HISTORIC DISTRICT COMMISSION

APPLICATION FOR WORK APPROVAL

HDC2025-00315

ADDRESS(ES): 2998 Iroquois Ave.

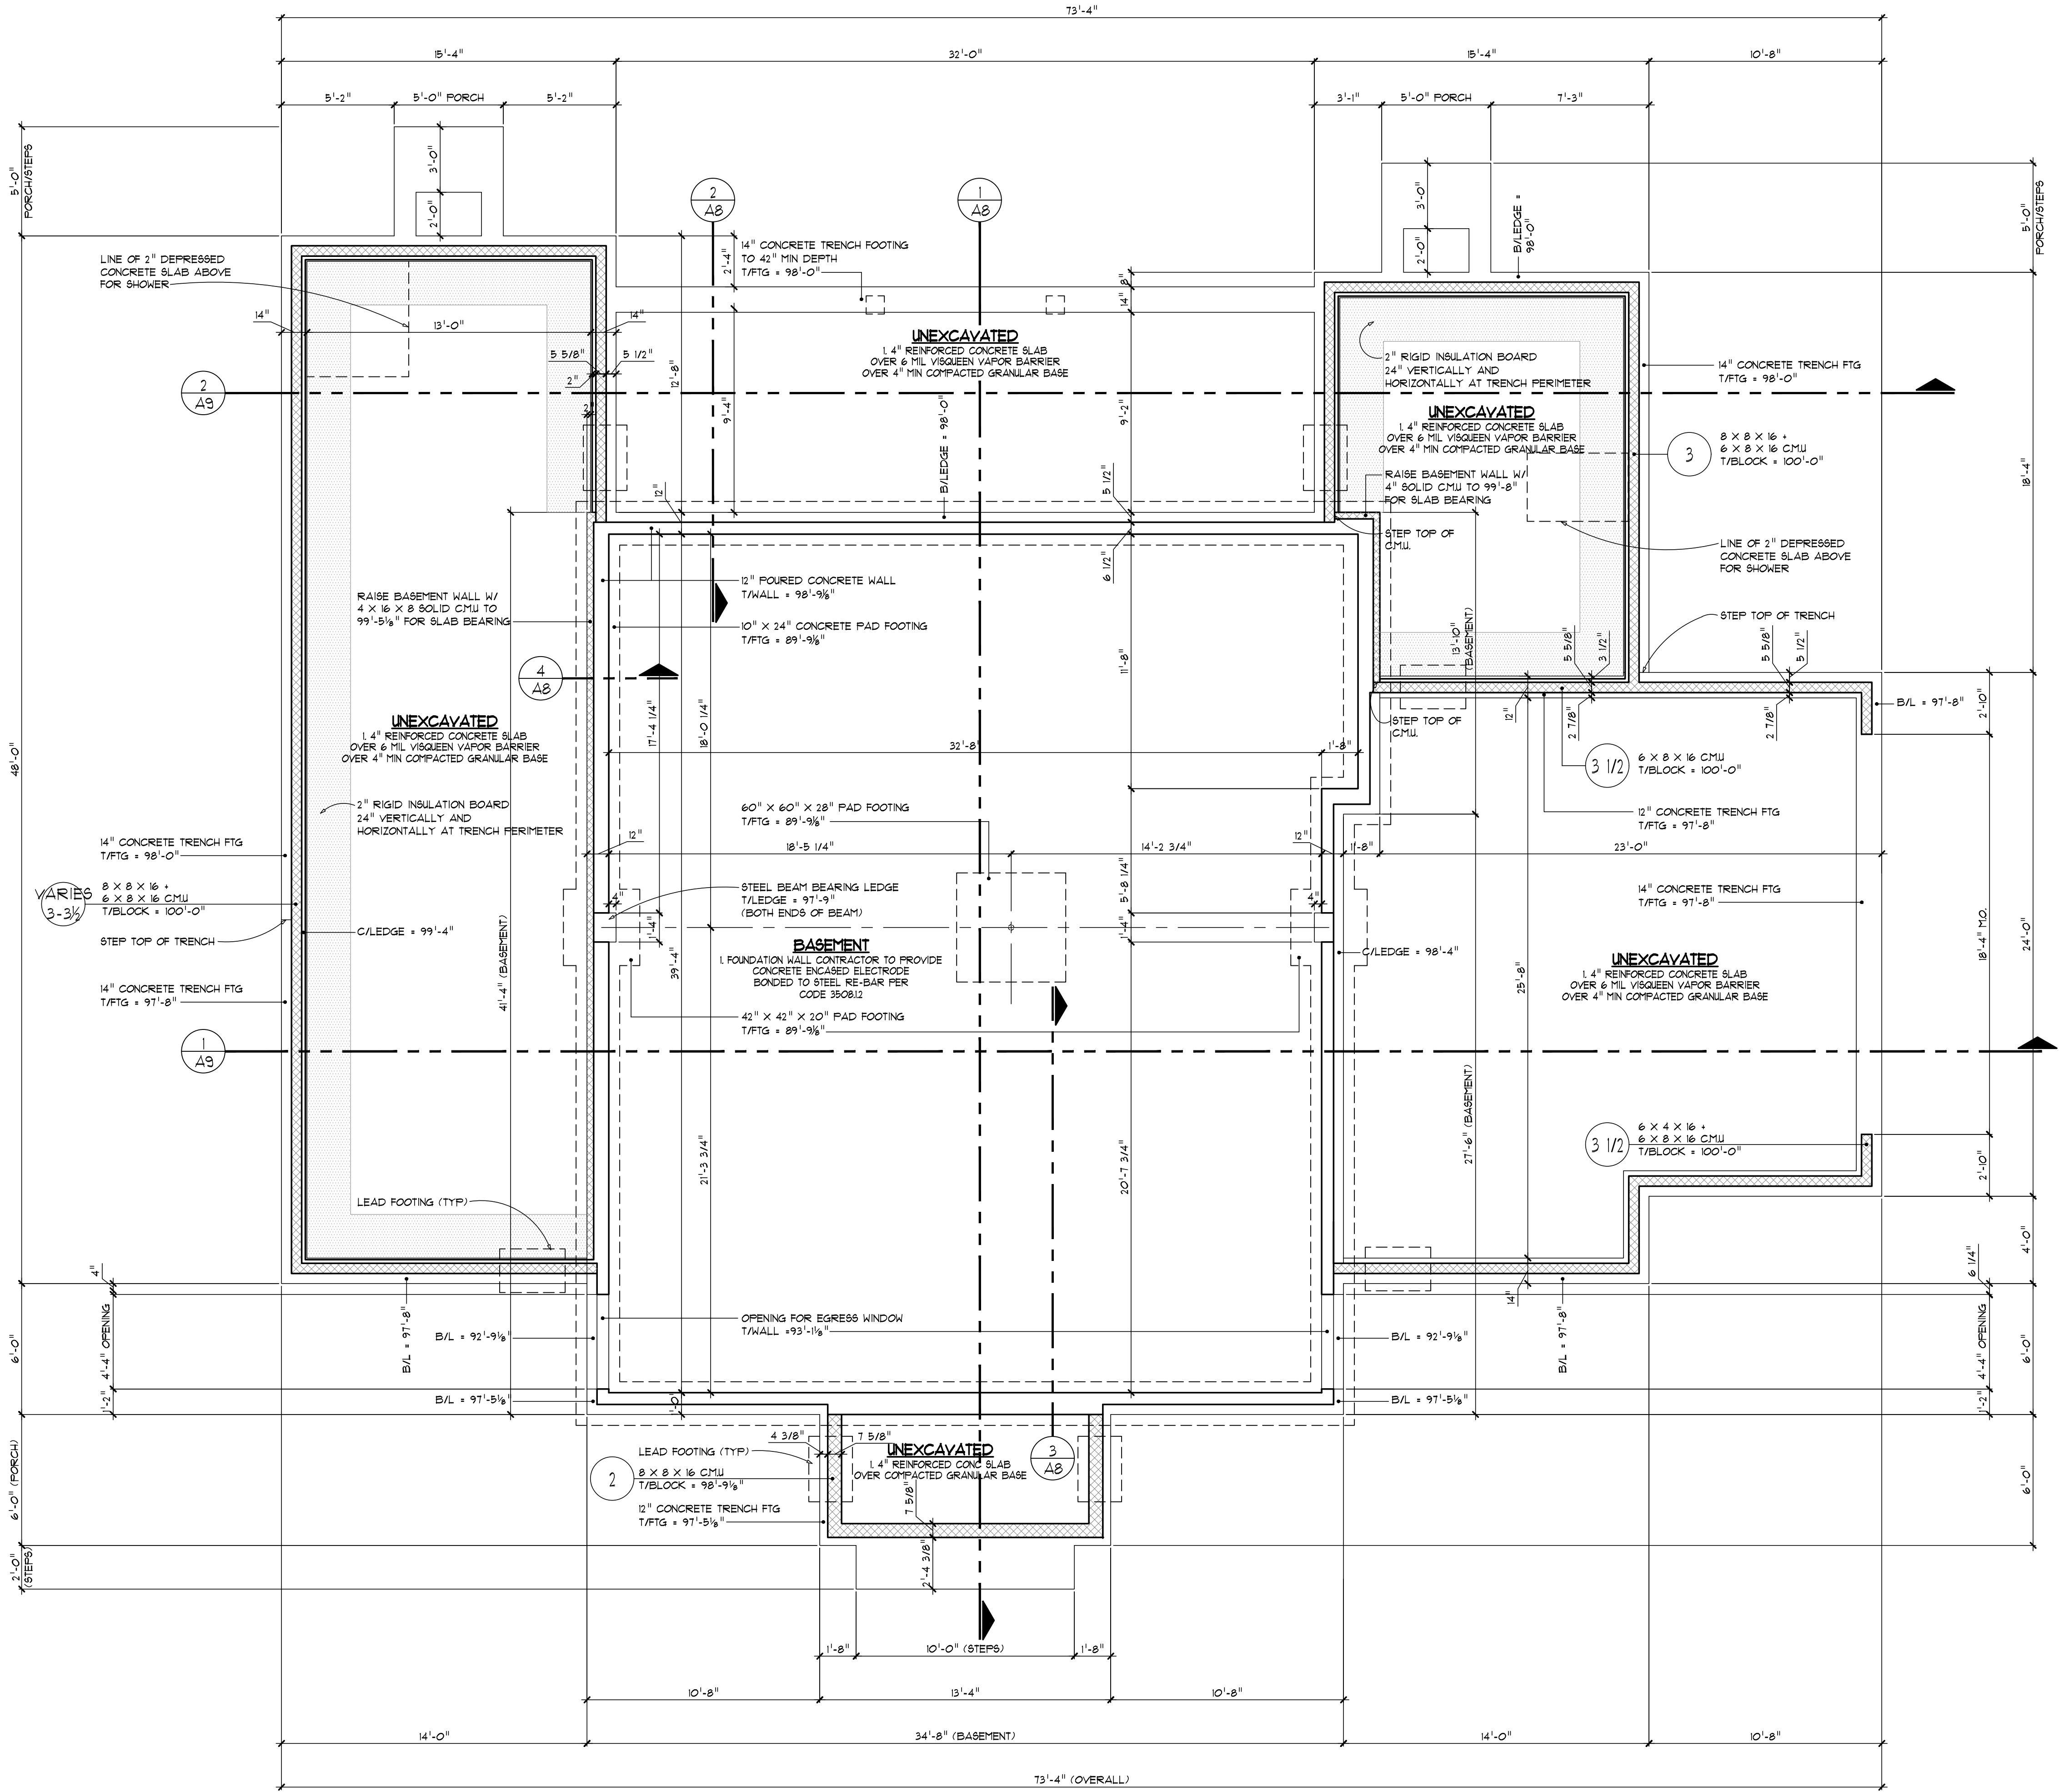
In the above photo, you will see two sample colors - the one on the fascia trim is the original approved color for the entire exterior of the home (SW 7554). In person, it came out too yellow for the homeowner. The color swatch on the lap siding is the new custom color that they would like to propose. Staff is welcome to visit the house to see the color swatches in person, they are to the right of the front door.
